Proposal for draft corrigendum to Revision 2 of Regulation N°44

A. PROPOSAL

Figure 1

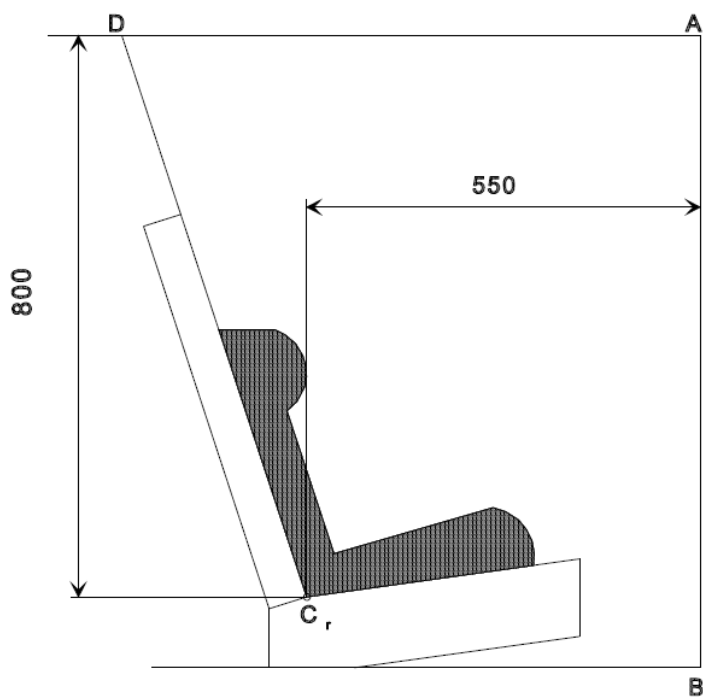
Paragraph 7.1.4.4.1.1., add the footnote:

7.1.4.1.10.2. For ISOFIX child restraint system of other size classes with the anti-rotation device in use." Paragraph 7.1.4.1.1., figure 1, insert a reference to a footnote 5/ to the 550 dimension, and insert the corresponding footnote 5/, to read:

*** / For the purpose of the test specified in paragraph 7.1.4.1.10.1.1., this dimension shall be 500 mm.**

"5/ For the purpose of the test specified in paragraph 7.1.4.1.10.1.1., this dimension shall be 500 mm."
